AGENDA

A. October 3, 2024

A. **SOUTH VILLAGE MSP**: The request is to bring **South Village Master Plan** back to the Platting Board for modification of the approved Conditions of Approval. The petitioner is proposing a community well until such time that City of Palmer water is available. The property is located east of N. 49th State Street, north of E. Palmer-Wasilla Highway, and directly south of W. Bogard Road (Tax ID # 18N01E36B020); within the NW ¼ Section 36, Township 18 North, Range 01 East, Seward Meridian, Alaska. In the Gateway Community Council and in Assembly District #2. (Petitioner/Owner: WM Construction, LLC, Staff: Matthew Goddard, Case # 2024-023)

MINUTES

EXHIBIT D 34 of 94

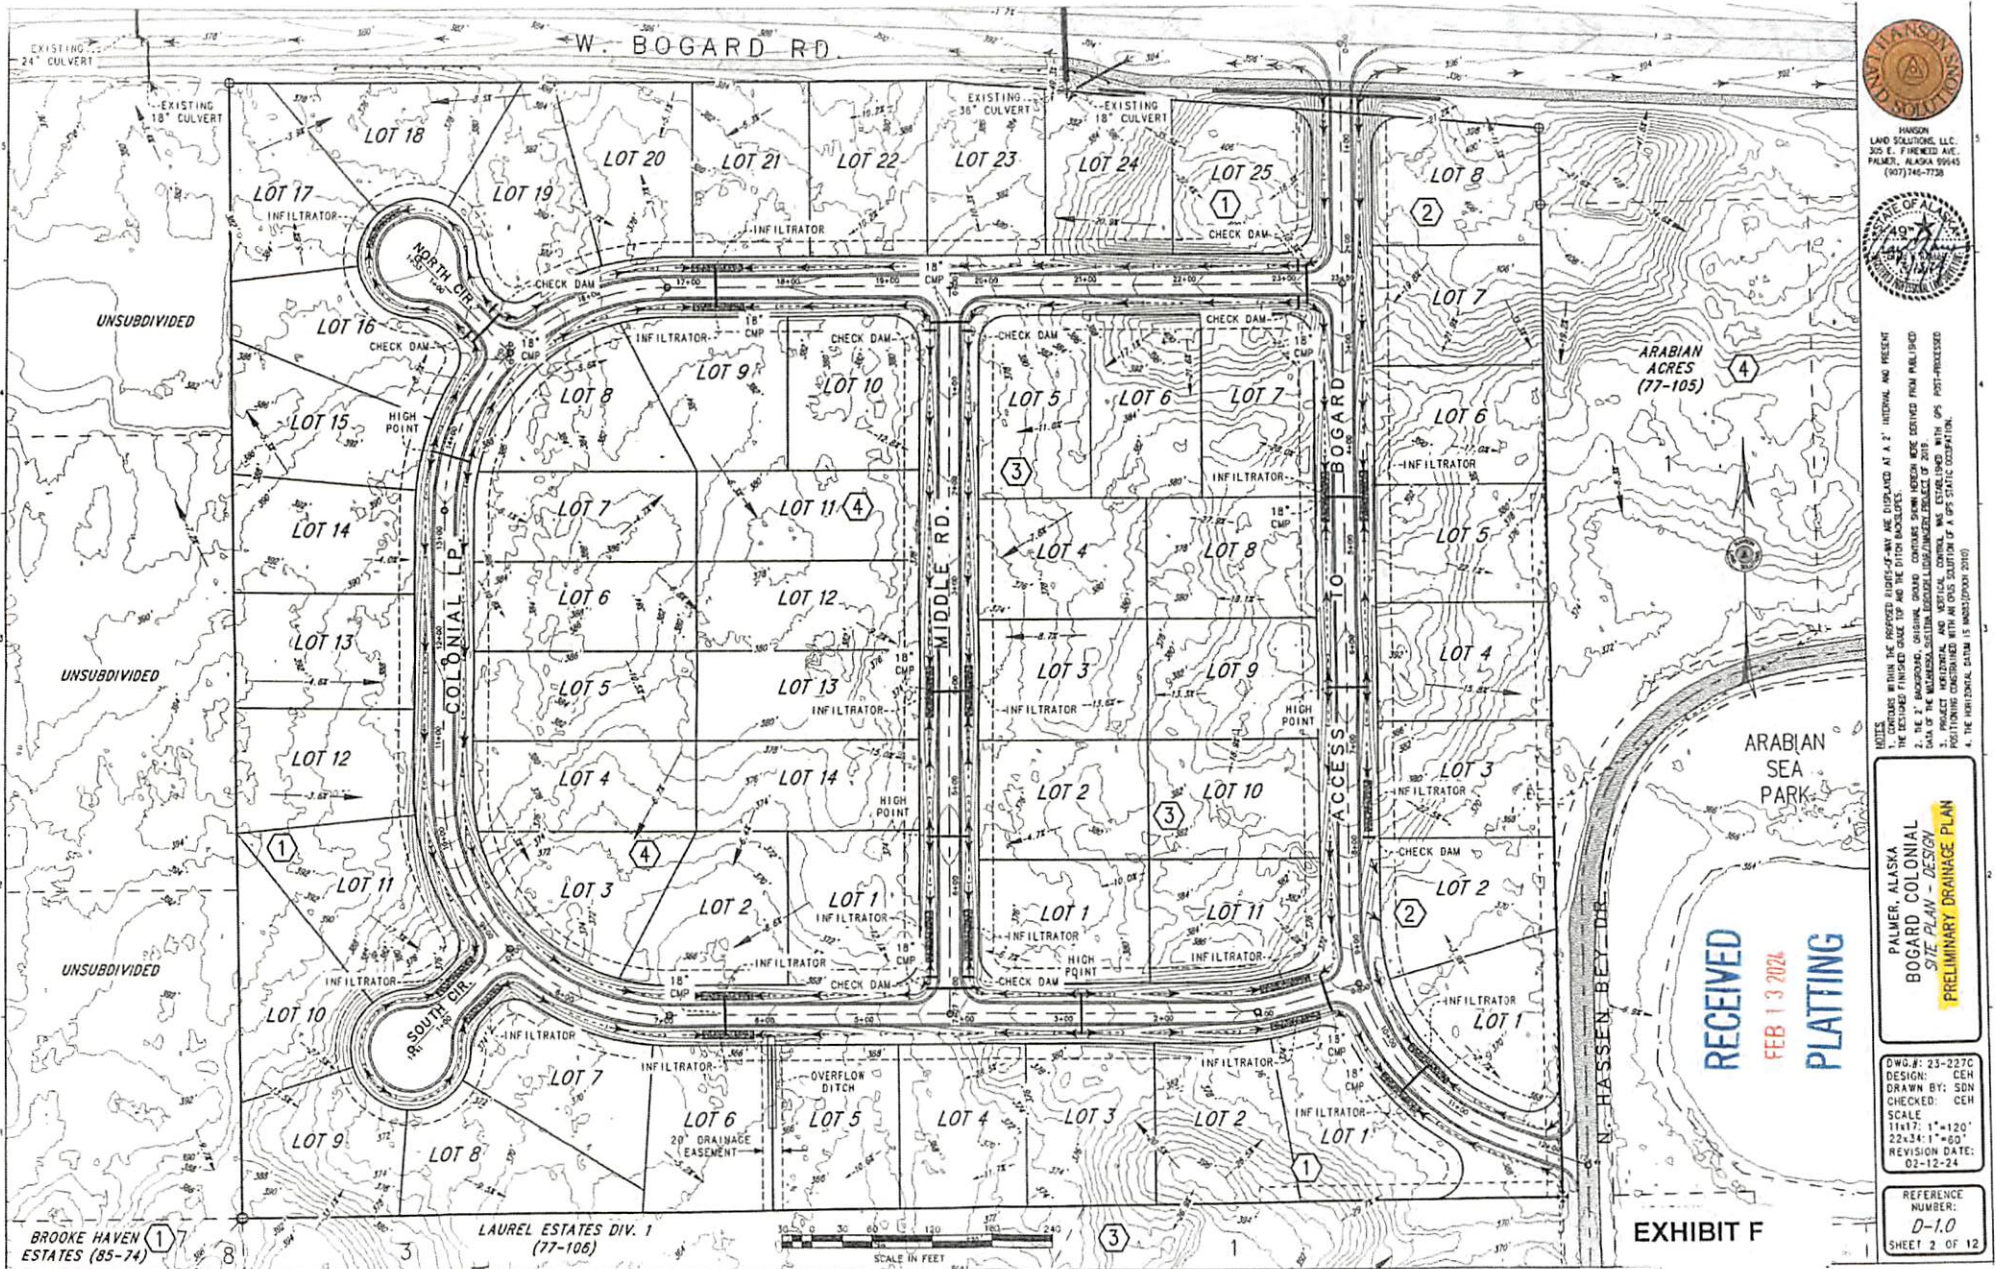
Preliminary drainage plan is at **Exhibit D-34**.

- g) Provide drainage retention area outside of MSB ROW.
 - h) Provide drainage easements across Lots 23 and 24 to facilitate flow coming from Bogard Road culvert located north of Lots 23 and 24 and reaching the area of detention.

EXHIBIT J
EXHIBIT D 61 of 94

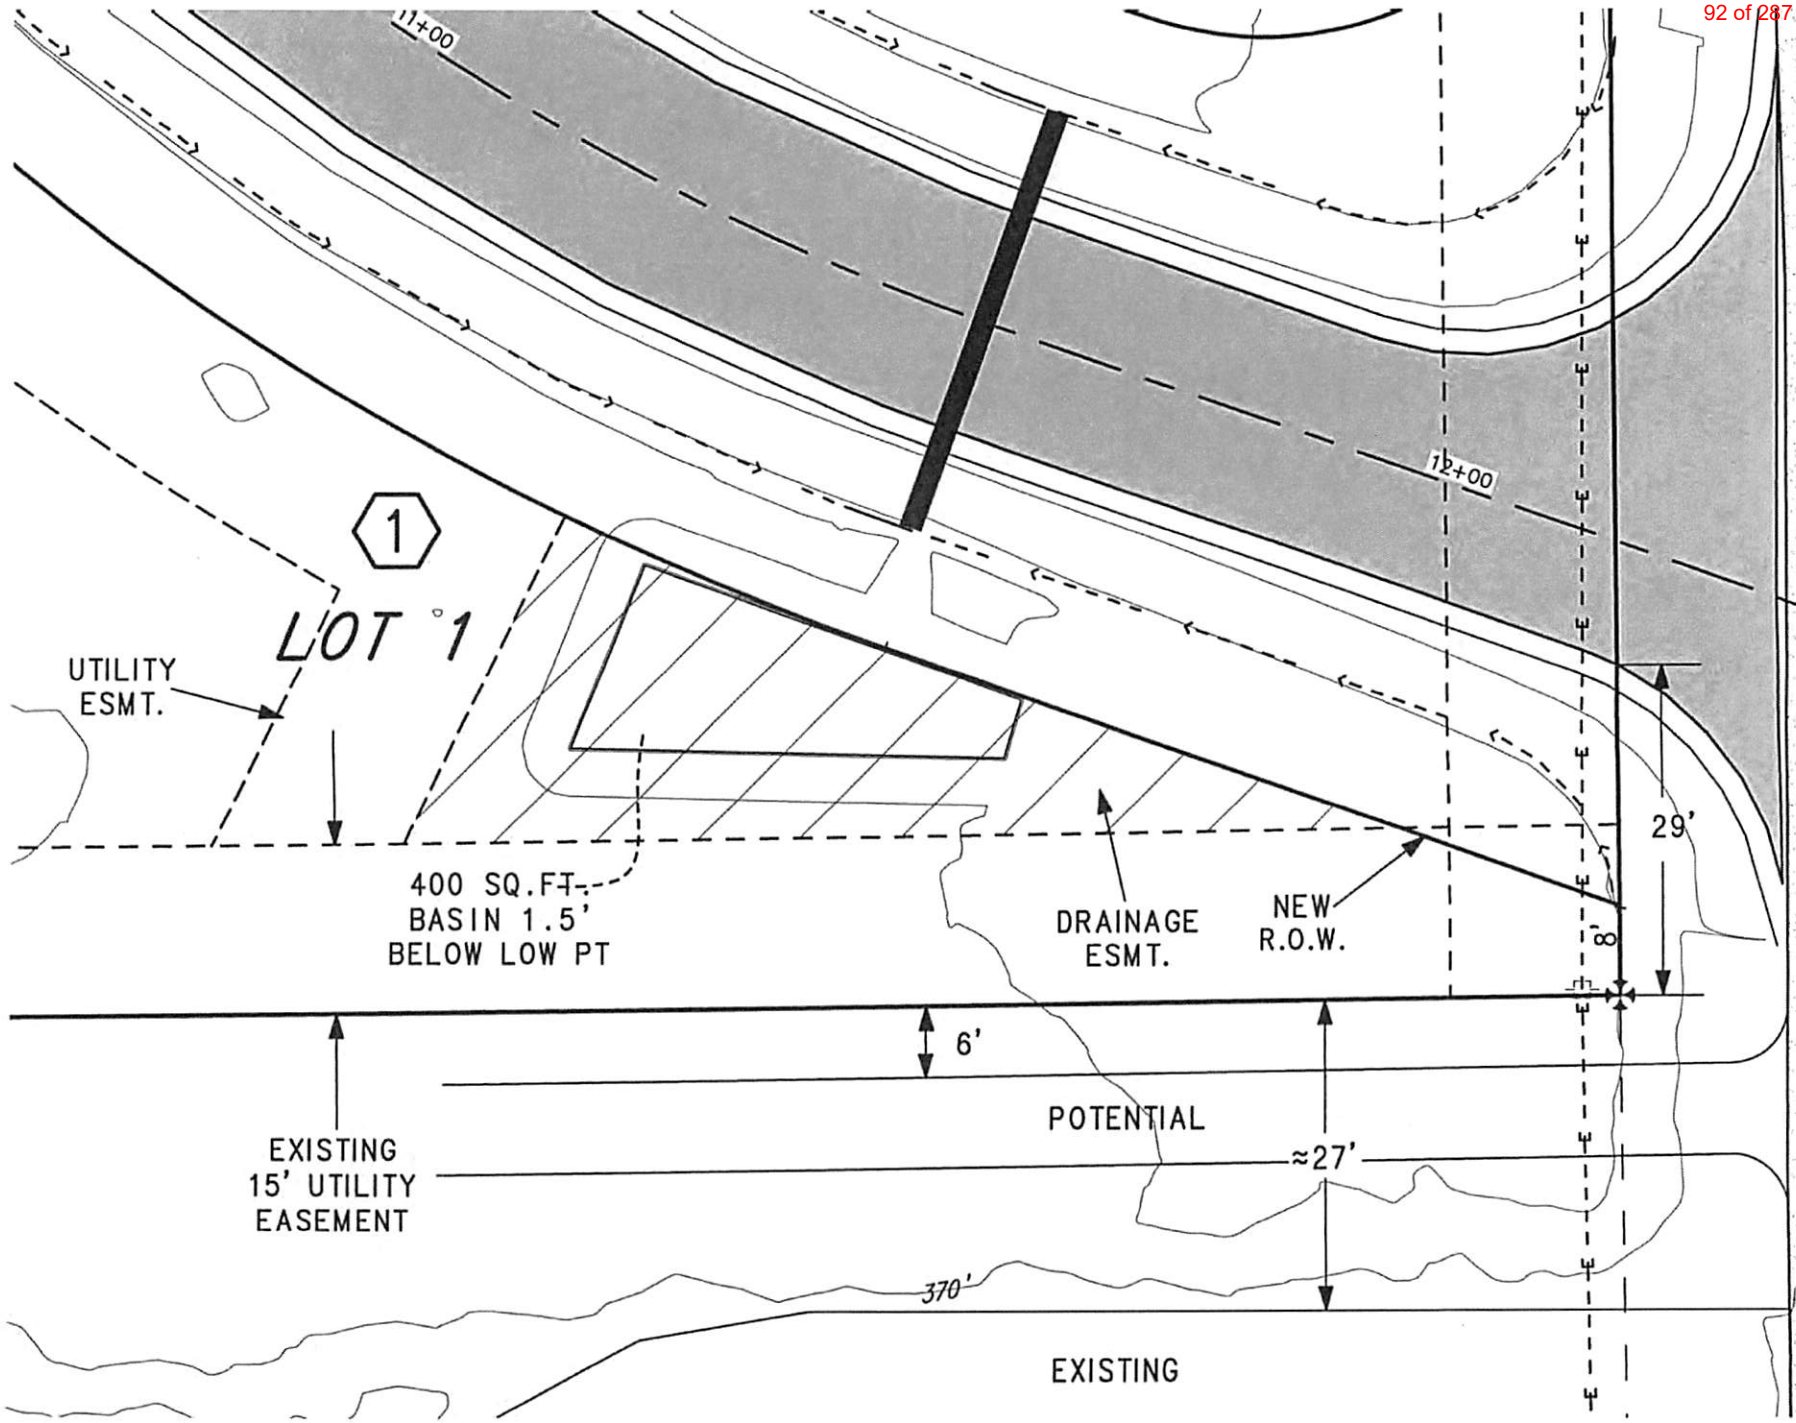
Modified design for access on to N. Hassen Bey Drive is at **Exhibit D-61**.

Comments: This does NOT meet current Borough Code. Please Comply with 2022 Subdivision Construction Manual which became part of the Borough Code 19 July 2022. Remove Hassenberg entrance as per A04.2 (c) and configure as referenced Figure A-2 Loop Residential Subcollector Streets. Accessed via Bogard middle of the lot as per A04.2 (e)

MSB Permit Center (Exhibit I) notes that there is an unpermitted driveway onto Hassen Bey Drive. The petitioner will need to either remove the driveway or apply for a driveway permit for the existing access (**Recommendation #17**).

17. Provide Platting staff a copy of all driveway permits/permit applications for all existing accesses, or provide proof of removal of non-permitted accesses.
